Wisconsin Department of Transportation

Proposal #23: 6243-00-64, WISC 2020 081
Shawano - Neopit
Shawano Cty Bridge Overlay B-58-60
STH 47
Shawano County

6243-08-70, WISC 2020 082
Shawano - Neopit
Shawano Creek To Menominee Co Line
STH 47
Shawano County

This is Addendum No. 01, which provides for the following:

Addendum No. 01
ID 6243-00-64
Revised Sheet 296
March 3, 2020

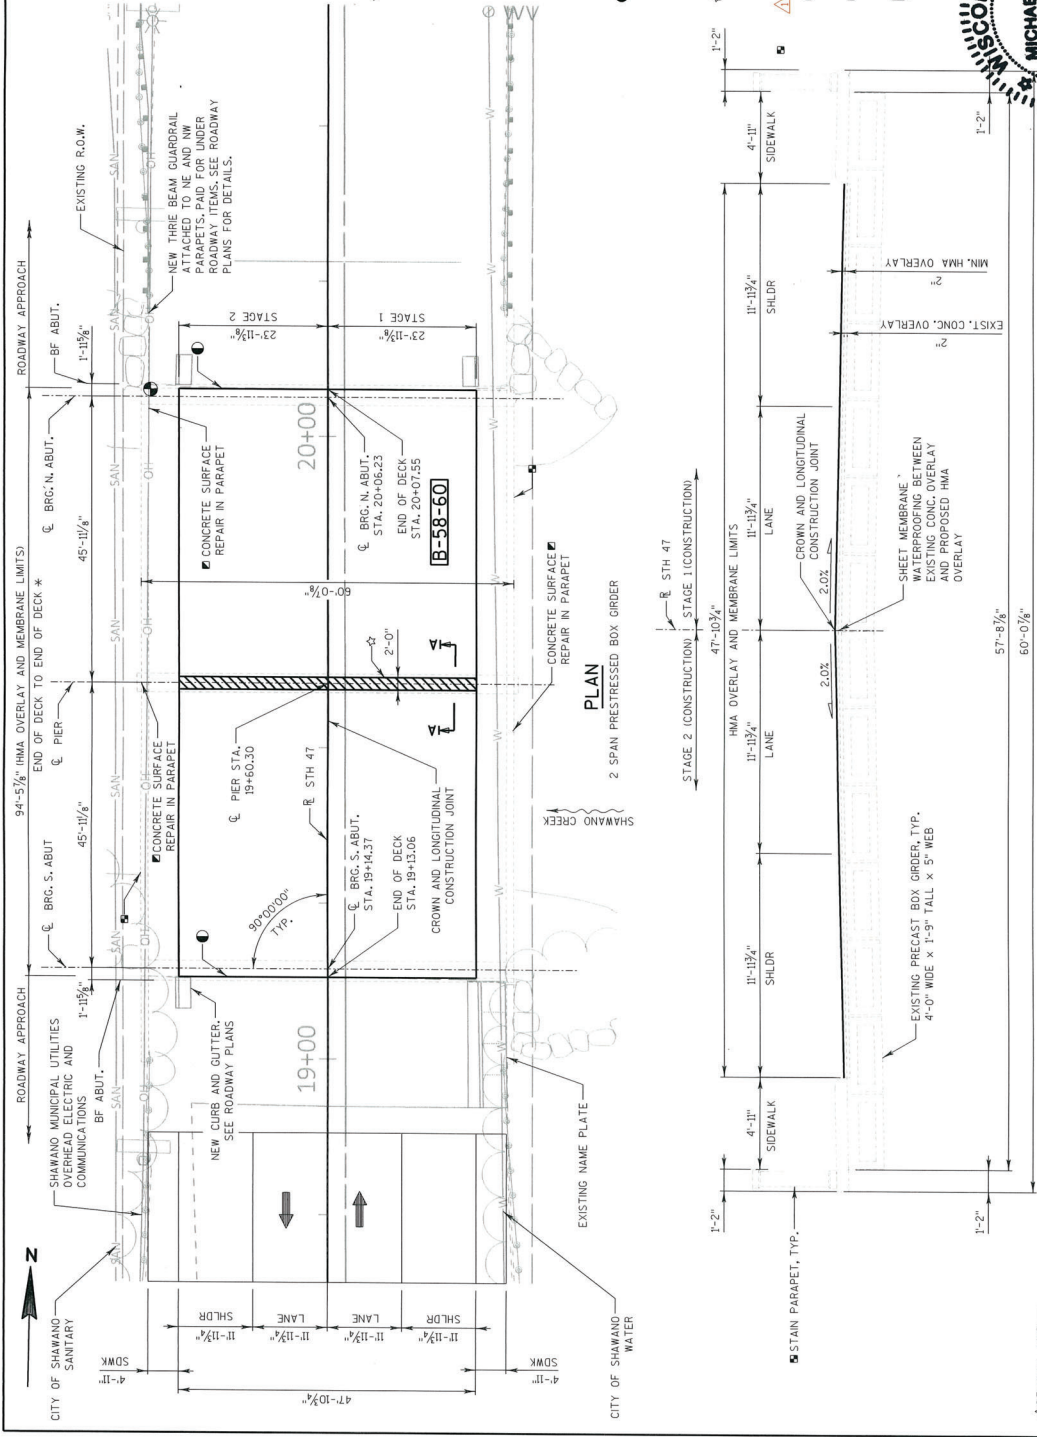
Revised Plan Sheets	
Plan Sheet	Plan Sheet Title (brief description of changes to sheet)
115	Adjust quantities to move the lower layer of HMA in widening areas to QMP HMA, notes were also adjusted to provide clarity on applicable incentive items
296	B-58-60 (revise note to indicate sawing is incidental to deck repair and correct quantity for item 509.9005.S)

- ✂ SAWCUT AND REMOVE EXISTING 2" UNREINFORCED CONCRETE OVERLAY OVER PIERS TO TOP OF ORDER. REMOVE AND SAWCUT PAID FOR UNDER BID ITEM "REMOVING CONCRETE MASONRY DECK OVERLAY B-58-60". REPLACE WITH CONCRETE UNDER BID ITEM "CONCRETE MASONRY DECK REPAIR". CURE FOR A MINIMUM OF 7 DAYS (PRIOR TO PLACEMENT OF SHEET MEMBRANE WATERPROOFING UNLESS OTHERWISE APPROVED BY THE FIELD ENGINEER).
